**Mandatory Product Update/Safety Bulletin**  
 PCWU 15-012 Rev C (Replaces PCWU 15-012 Rev B)  
 PC3/Titan Overspeed Safety Device  
 January 20, 2016

SUB COMPONENT
Overspeed Safety Device - Flywheel Assembly

**FIG C1**

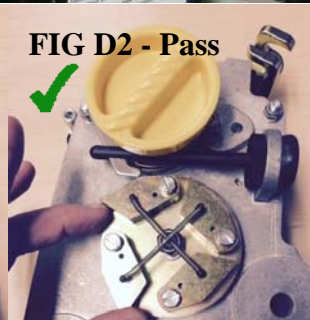
1. Prior to performing Daily Inspection Procedure checks, with Service Lift power off, remove Hoist Mainframe Cover (Fig C1) using a 4mm T-Handle. Locate the Flywheel Assembly (See Fig C2). **Manually rotate each flywheel counterweight (4 Total) on Flywheel Assembly** of the Overspeed Safety Device to ensure that their rotation past the outer diameter of the flywheel is limited as shown in Fig D1 & D2 below. If it can move too far and get caught on obstacles other than the trigger for the stop as shown in Fig E, the Flywheel does not pass inspection.
